CITY OF ALBUQUERQUE

**Re: Lot 7 Block 8 Volcano Cliffs Unit 4
6728 Mariposa Pl NW
Grading & Drainage Plan
Engineer's Stamp dated: 2-2-18 (D10D012)**

**6728 MARIPOSA PLACE, NW
GRADING PLAN**

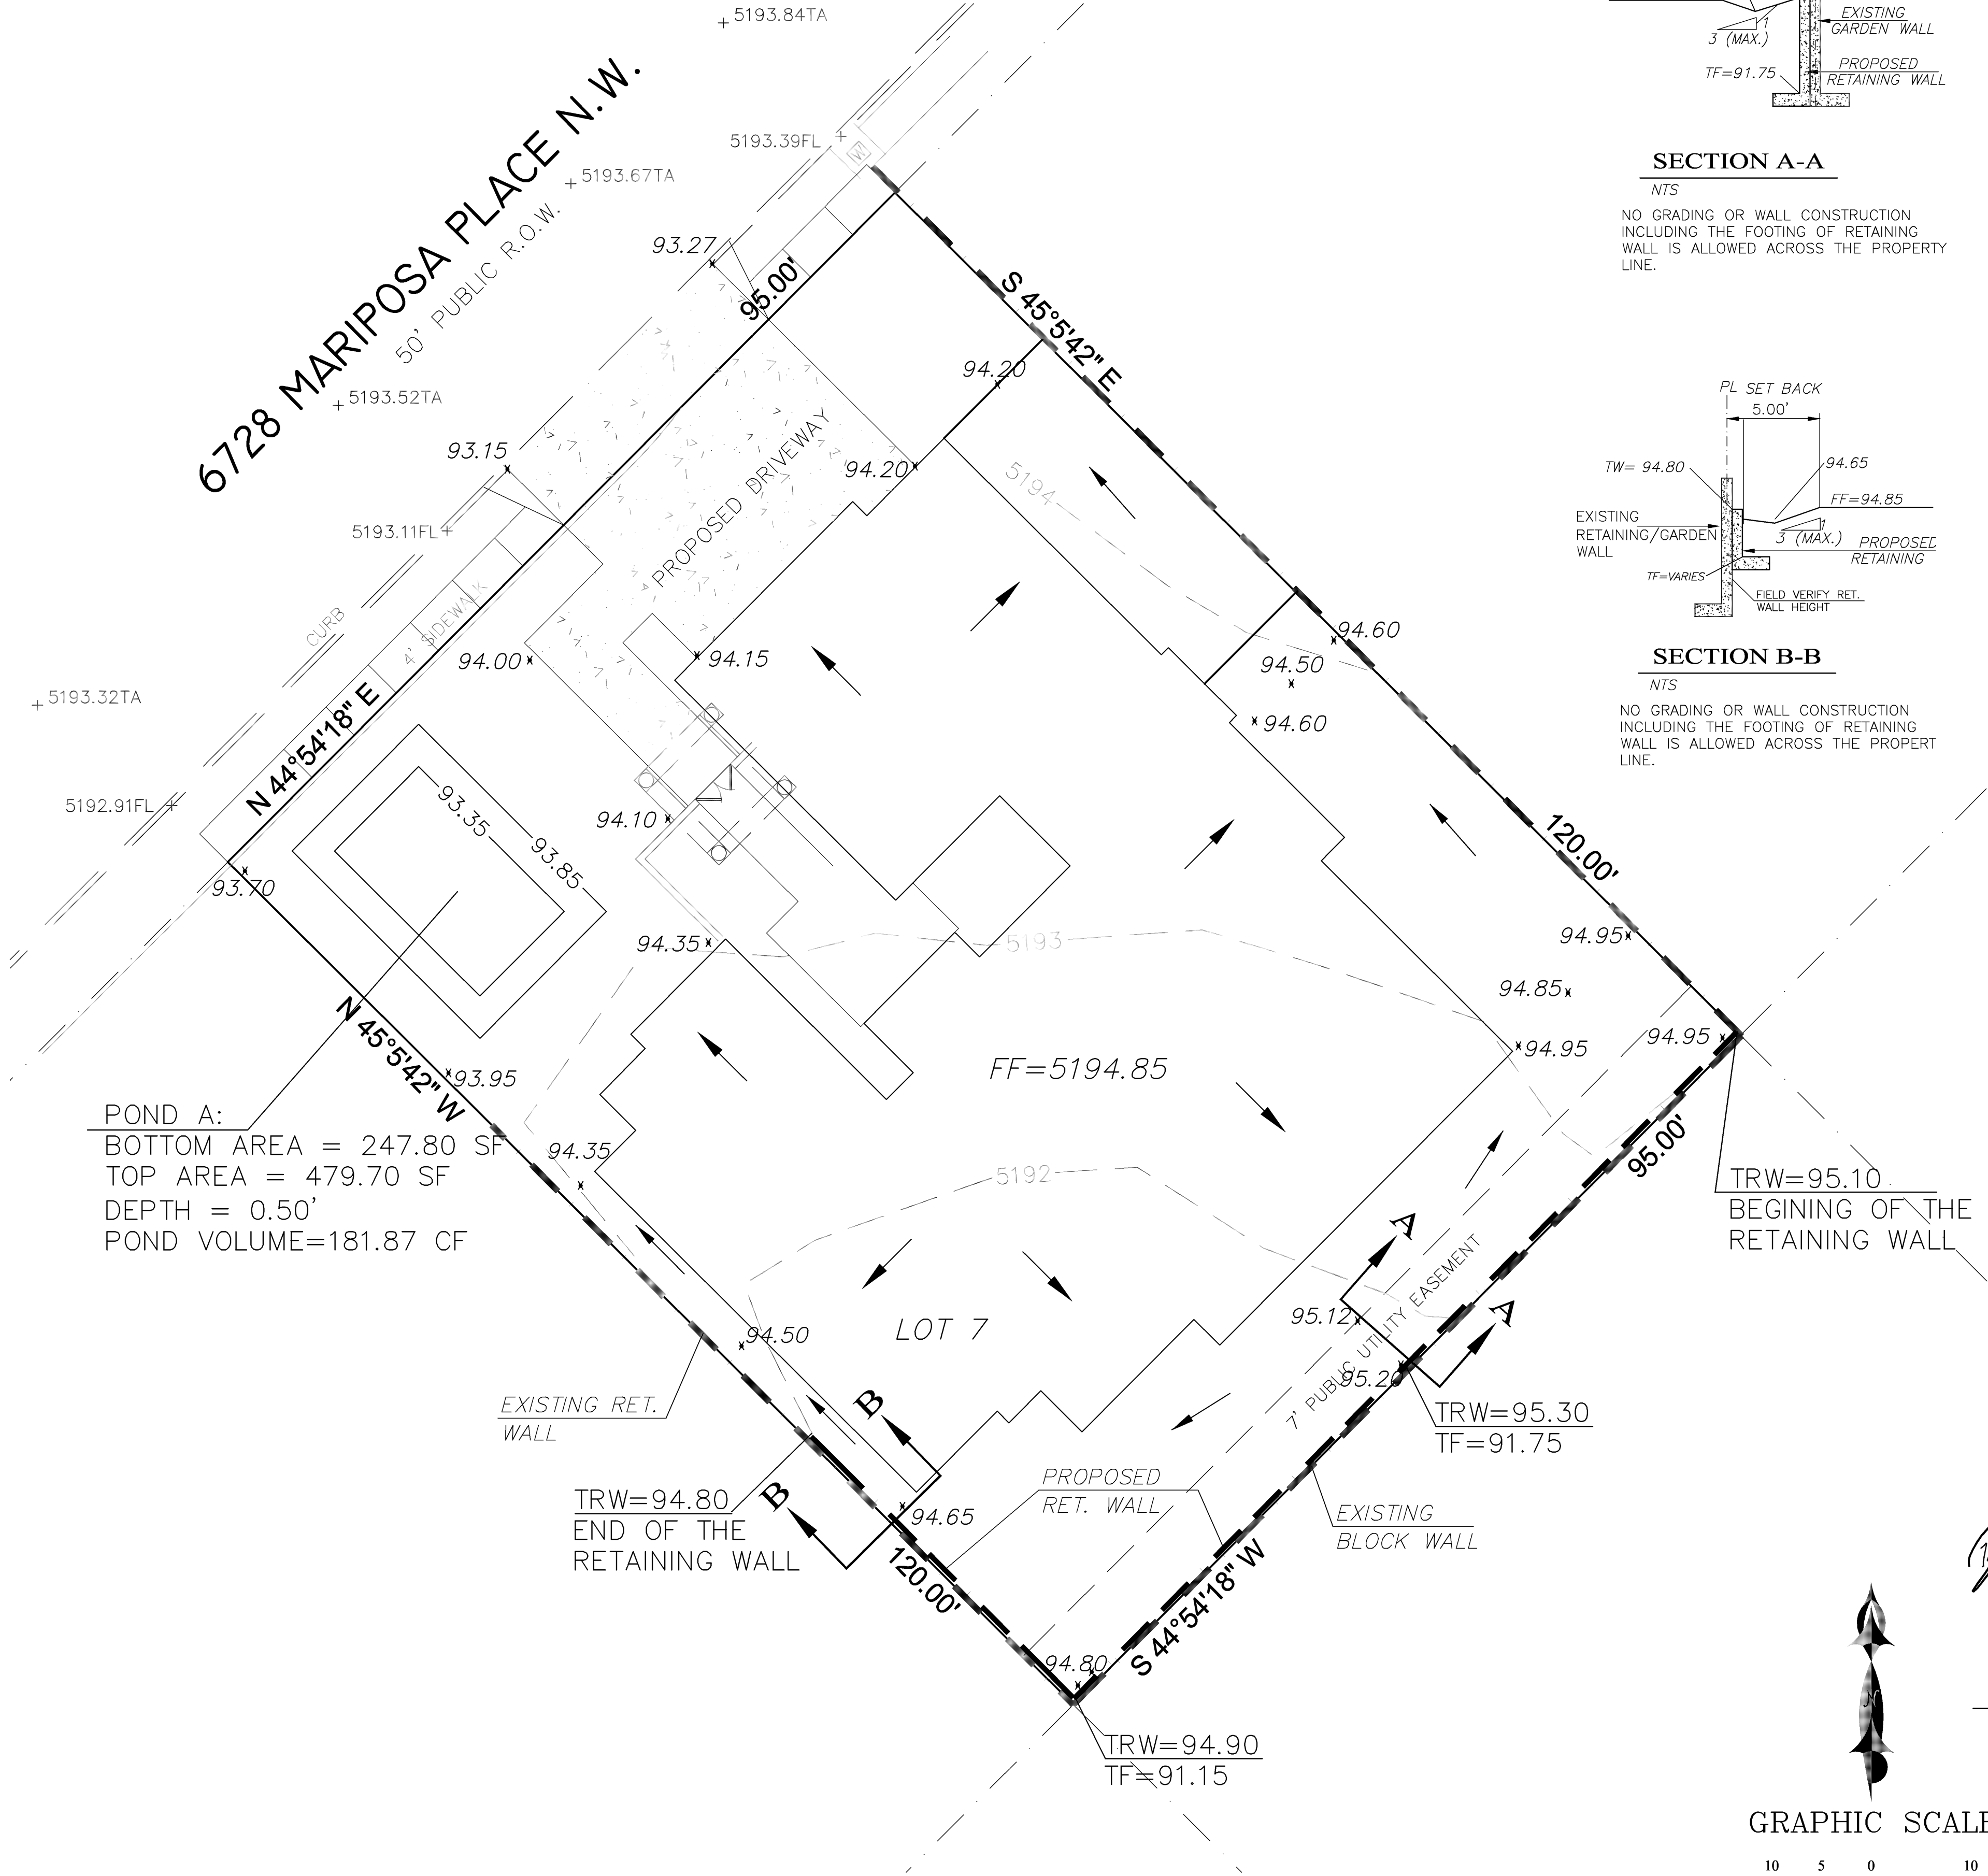
Based upon the information provided in your submittal received 2/2/2018, this plan is approved for Grading Permit.

Reiterate to the Owner/Contractor that a separate permit for a garden/retaining wall must be obtained, with the approved G&D plan dated 2/2/18.

Prior to Building permit approval a Pad Certification will be required, provided by the Engineer with pad cert language or a registered Land Surveyor with as build spot elevations.

Prior to Certificate of Occupancy release, Engineer Certification per the DPM checklist will be required.
